# **Korea Opinion on UN R127 Amendment Proposal (GRSP-2020-09e)**

Ministry of Land, Infrastructure and Transport  
Korea Automobile Testing & Research Institute  
of Korea Transportation Safety Authority  
2020.7.

# Correlation - vehicle height and head impact position

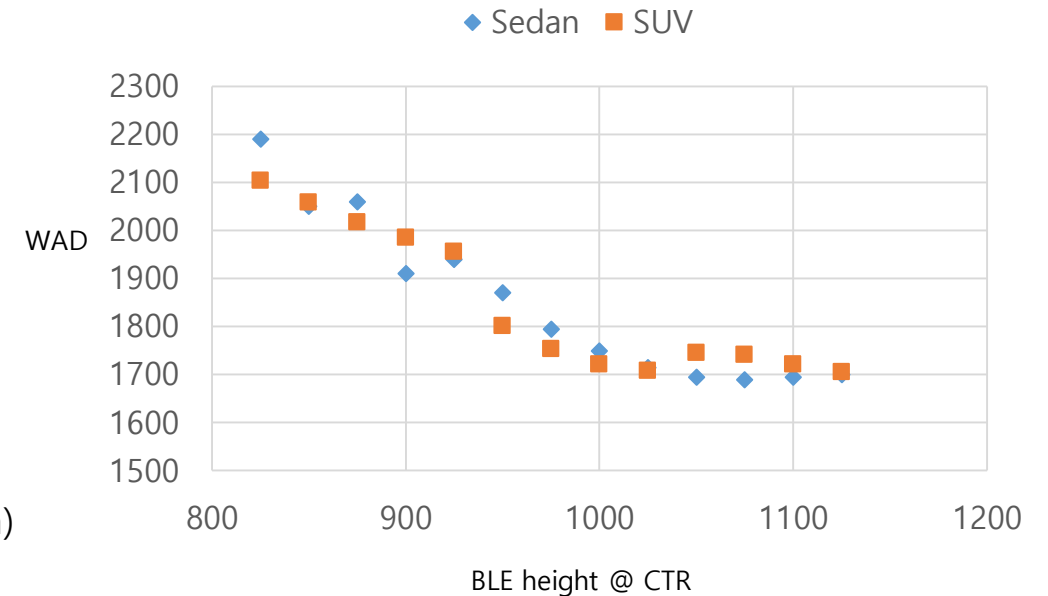
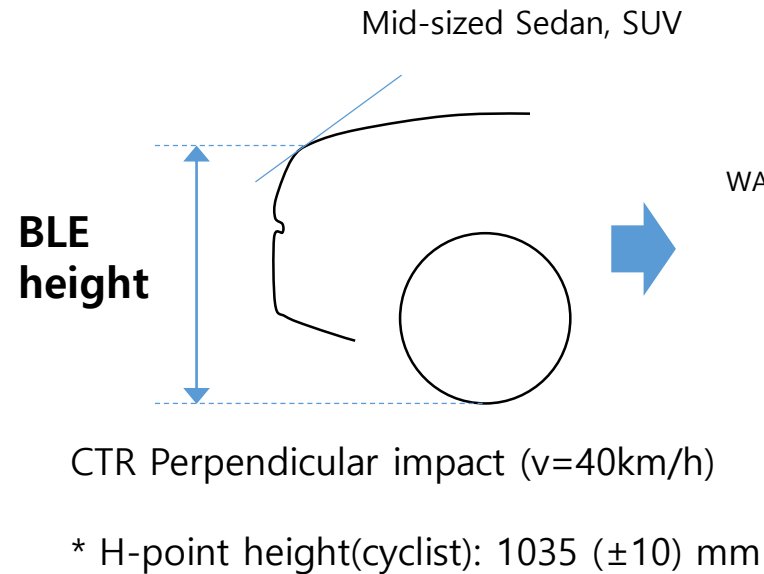
- In case the BLE height is higher than the H-point height of the cyclist, the head impact point location(WAD) seems unchanged and below WAD 2100

- Rear extension boundary(WAD 2500) in UN R127 amendment proposal(GRSP-2020-09e) is an appropriate level
- However, based on the simulation result, head impact positions of cyclists beyond WAD 2100 are unlikely to occur in case of vehicles with high front design like large SUVs
- Republic of Korea would like to propose WAD 2100 (current limit) as the rear extension boundary in case that the vehicle has a higher BLE height than [ 1035 mm ]
  - proposal: GRSP-2020-9e + additional provision for exception
  - other parameters and standards are considerable instead of BLE height(@CTR) and the square value
